SERVICE ADVISORY

NO.: 1479 Rev A

SUBJECT: GTN 6XX/7XX Catalog Flight Plan Menu Preview

All Garmin GTN 6XX/7XX units using Main Software Version 5.10 through Version 5.13.

Figure 1: Catalog Flight Plan Menu

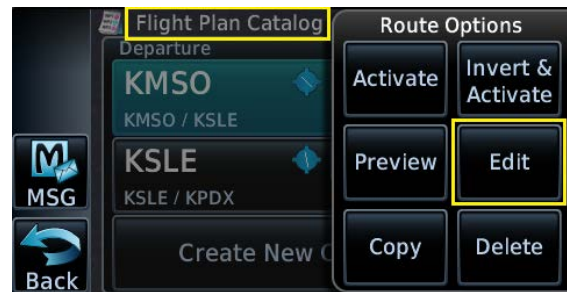
Do not use the Preview key on the Catalog Flight Plan Menu.

Editing a Catalog Flight Plan after previewing the Catalog Flight Plan from the “Catalog Flight Plan Menu” may cause changes to the Active Flight Plan.

5. **NOTE:** There may now be magenta data and/or arrows indicating that edits may affect the active flight plan. Magenta data fields and/or arrows should never be present when viewing a catalog flight plan.

Editing the cataloged flight plan may actually make edits directly to the active flight plan.

This issue will be addressed in future software revisions.
